# UNITED STATES PATENT AND TRADEMARK OFFICE

APPLICATION NO.	FILING DATE	FIRST NAMED INVENTOR	ATTORNEY DOCKET NO.	CONFIRMATION NO.
10/815,581	03/31/2004	Michael J. Antal JR.	UOHIP006D1	9383
22434	7590	08/04/2006	EXAMINER	
BEYER WEAVER & THOMAS, LLP			NECKEL, ALEXA DOROSHENK	
P.O. BOX 70250			ART UNIT	
OAKLAND, CA 94612-0250			PAPER NUMBER

## Office Action Summary

## **DETAILED ACTION**

Figure 2. Schematic of the laboratory reactor.

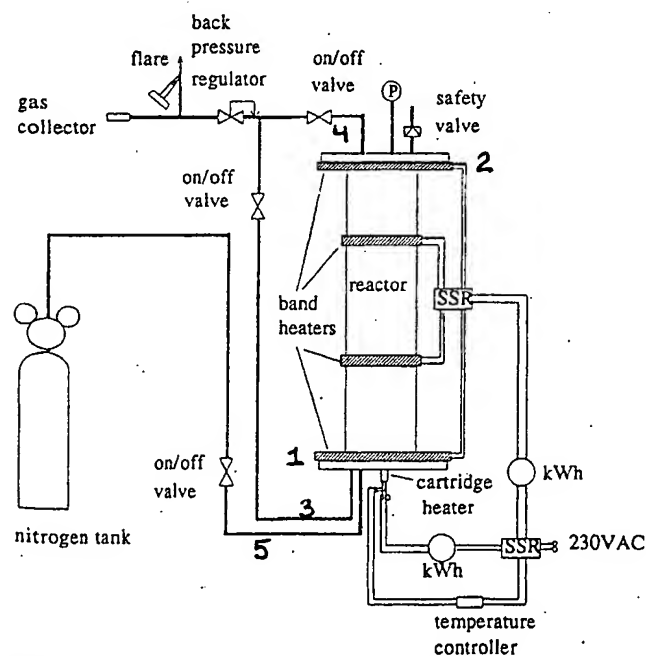
With respect to claim 20, Antal Jr. et al. discloses a reactor (figure 2) which comprises a housing (pressure vessel) with a sealable opening (pressure-tight hinged closure) for receiving a removable canister with a lid; heaters which heat the distal end (2) of the canister (fig. 2) (page 653, col. 2, paragraph under "Apparatus and

Experimental Procedures"); a first valved exit orifice (3) at a proximal end (1) and a second valved exit (4) orifice at a distal end (2) of the housing (pressure vessel); and a valved entry orifice (5) at the proximal end (1) (page 653, col. 2, paragraph under "Apparatus and Experimental Procedures").

Figure 2 of Antal Jr. et al. does not provide reference numbers, so the examiner has numbered various elements below to provide further clarification of how the reference has been applied.

With respect to claim 22, Antal Jr. et al. further discloses wherein a flare (burner) is in communication with the second valved exit (4) (see figure 2).

With respect to claim 24, the schematic illustration of Antal Jr. et al. has been applied so that the proximal end (1) is at the bottom and the distal end (2) is at the top of the vertically arranged device shown in figure 2. The device of Antal Jr. et al. arranged so that the proximal end (1), and its associated elements, is at the top while the distal end (2), and its associated elements, is at the bottom of the vessel would still be the same apparatus (only turned on end). It appears from the description of the operation of Antal Jr. et al.'s device, that in such an orientation, the device would continue to be operational. It has been held that there is no invention in shifting the location of parts when the operation of the device would not thereby be modified. In re Japikse, 86 USPQ 70 (CCPA 1950).

The schematic of the apparatus of Antal Jr. et al (figure 2) only illustrates that the valved entry (5) passes into the proximal end (1) but fails to illustrate if it extends into the canister.
